**ADDENDUM NO. 1  
CITY OF PEORIA  
Green Infrastructure Maintenance – CSO Year 1 & 2  
July 15, 2025**

Re: Addendum for Bid Package, **Green Infrastructure Maintenance – CSO Year 1 & 2**,  
Peoria, IL

**PIPE DRAIN TRENCH DETAIL**

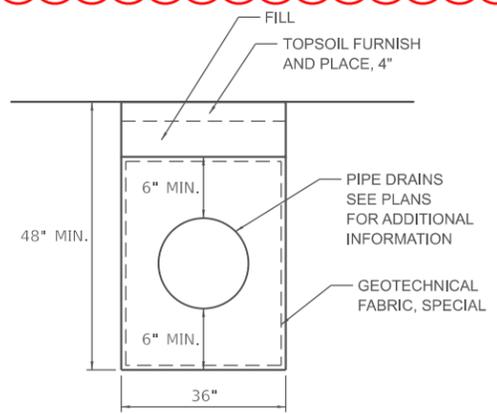
1. Replace FABCO Detail KSA1127-2H-000 with updated detail that provides a wider basket for ease of maintenance.
2. Sheet 14 – Revise Pipe Trench Detail to limit use of Geotechnical Fabric, Special from bottom of trench.

**NOTES:**  
 1. GEOTECHNICAL FABRIC, SPECIAL SHALL BE OMITTED FROM THE BOTTOM OF THE TRENCH WHEN SAND IS PRESENT.
